Fernald Closure Project  
Letter No. C:SP:2004-0036

Mr. Thomas A. Winston, District Chief  
Ohio Environmental Protection Agency  
Southwest District Office  
401 East Fifth Street  
Dayton, Ohio 45402-2911

**DISCHARGE CHANGES – NATIONAL POLLUTANT DISCHARGE ELIMINATION SYSTEM  
PERMIT NUMBER 11000004\*GD FERNALD CLOSURE PROJECT**

# CAWWT Process Flow Diagram

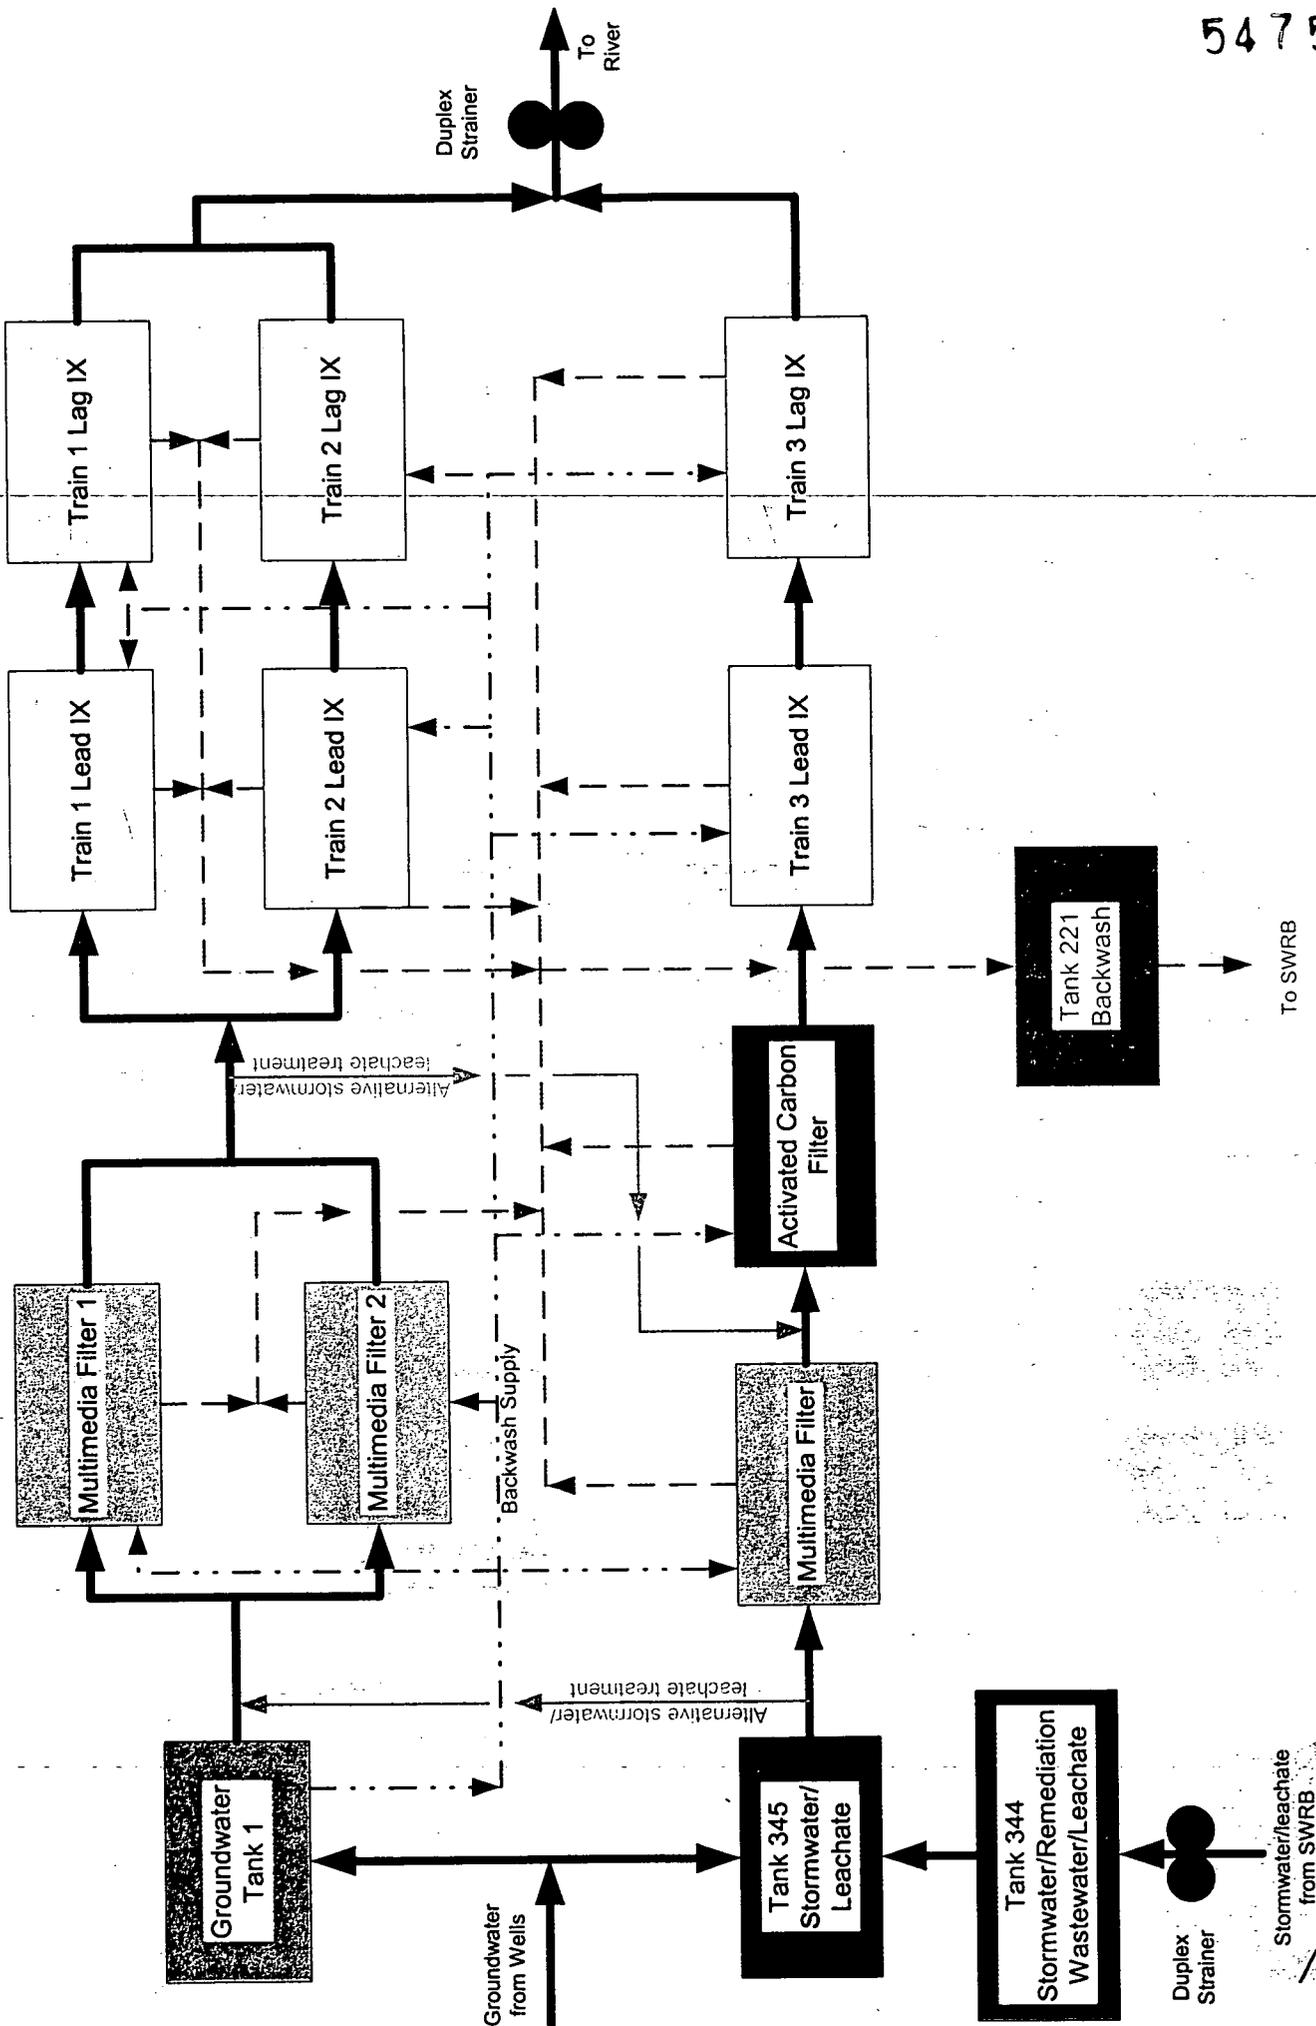
The culmination of the above negotiations and consultations led to the USDOE proposal that the existing AWWT would be reduced down from the 2,600 gpm three phase facility to a modified 1,800 gpm facility (two distinct treatment trains; one 600 gpm and one 1,200 gpm) by eliminating AWWT Phases I and II and modifying the AWWT Phase III Expansion system including the addition of activated carbon to the 600 gpm treatment train (reference 3). This proposal has been accepted by all key stakeholders and USDOE's proposal has been approved by USEPA (reference 4). Comments from the Office of Federal Facilities Oversight of OEPA have been incorporated into this proposal as well. This modified facility (Converted Advanced Wastewater Treatment system or CAWWT) will

contain the same unit operations as the existing facility with the exception of clarification/sedimentation. However, by implementing multi-media filtration solids removal will be acceptable.

As identified above, the CAWWT will be operated in two distinct treatment trains until all treatment obligations for contaminated storm water and remediation wastewater are completed in June 2006. Of the 1,800 gpm CAWWT, a 600-gpm treatment train containing the activated carbon will be used for treatment of all necessary contaminated storm water and remediation wastewater while a 1,200-gpm train will be dedicated to the treatment of groundwater. A process flow diagram of the new CAWWT and an overview of the timeline for implementation are included as attachments.
